Answers to PRD Referee's Comments on the paper
"Study of Jet Shapes in Inclusive Jet Production in pp-bar collisions at $\sqrt{s} = 1.96$ TeV

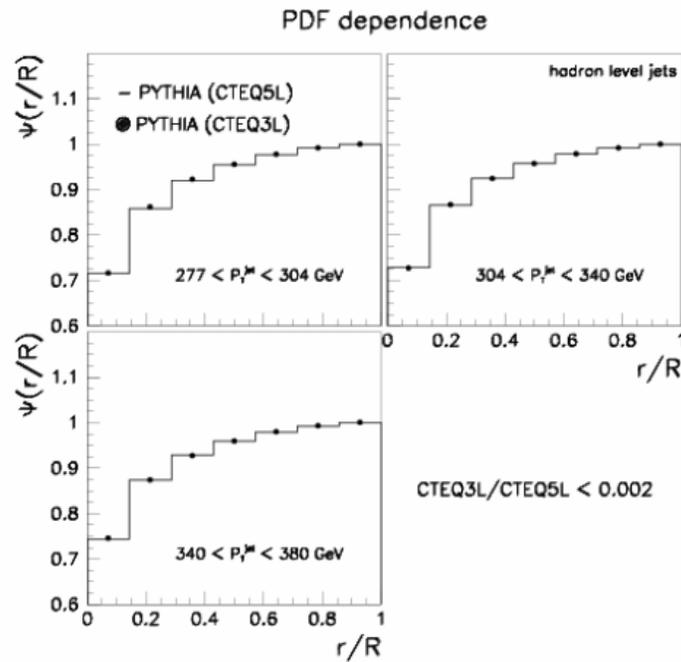
The simulations were limited to the CTEQ5L pdf and apparently a single renormalization scale choice. How much does jet shape depend on these choices? Given the later assertions that the jet shape at high momentum transfer reflects the changing gluon/quark content and the known pdf uncertainties at high x some investigation of the jet shape with alternate pdf's is appropriate. The predictions for shape in the highest P_t bin should be repeated with a competing pdf. The predictions with alternate renormalization scales should also be repeated at a lower P_t bin where the highest sensitivity is expected. These studies would establish how much shape variation could be attributed to these choices. At the very least the authors should explain why these studies are not necessary.

We studied the dependence of the predicted jet shapes with the PDFs by using CTEQ3 set (which does not take into account the Run I measurements of the inclusive cross section and thus underestimates the gluon distribution in the proton at very high- x). We decided to make this very extreme test since we suspected the sensitivity of the jet shapes to the change of the gluon distribution would be marginal since it is shielded by the amount of initial state-radiation allowed in the MC. You find an example of the test below. The effect was found to be less than 0.2%, well inside our uncertainties.

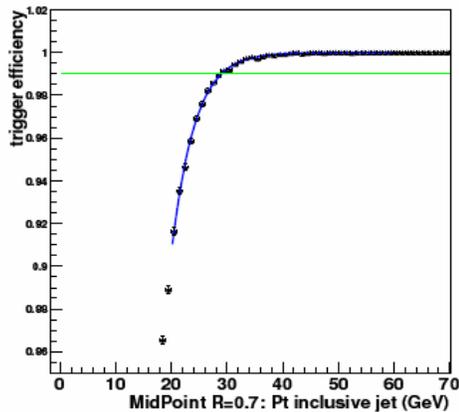
The minimum transverse energy of 37 GeV eliminates trigger bias. At what minimum threshold does bias occur and at what rapidities? Ideally a plot of efficiency as a function of pt and rapidity would be nice to see.

You find below the figure of the trigger efficiency for central jets ($0.1 < Y < 0.7$). The cut on 37 GeV allows us to stay in the plateau after considering the energy scale uncertainty present in the measurement. We do not consider, however, that this figure is necessary in the paper.
